The application of 4M change

Supplier: Zhe Jiang Rectron Electronic Co., Ltd

Item	1A1-1A7	Supplier					
		GM	SALE	PURCHASE	PE	QRA	Prepared
P/N	1A1-1A7						
		Richard	Robert	LH LU	Dick	Mark	Mark

Marking on the body

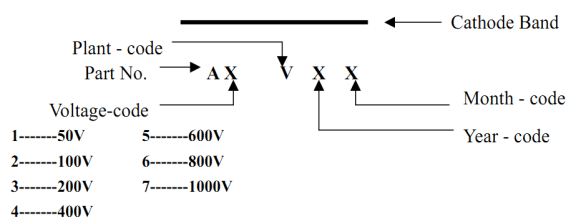
- 1) Device body marking change from "1A1", "1A2"...etc to "1AH".
- 2) Maximum Recurrent Peak Reverse Voltage (V_{rrm}) rating upgraded as below.
1A1 from 50V to 1000V 1A4 from 400V to 1000V 1A6 from 800V to 1000V
1A2 from 100V to 1000V 1A5 from 600V to 1000V 1A7 no change
1A3 from 200V to 1000V
- 3) No other fit, form or function changes
- 4) If the customer disagrees with the change, We will use Z to distinguish the material number.
- 5) P/O: P/N-packing code-Z; Type: P/N-packing code; Remark : -Z (For example: P/O: 1A7-F-Z; Type: 1A7-F)
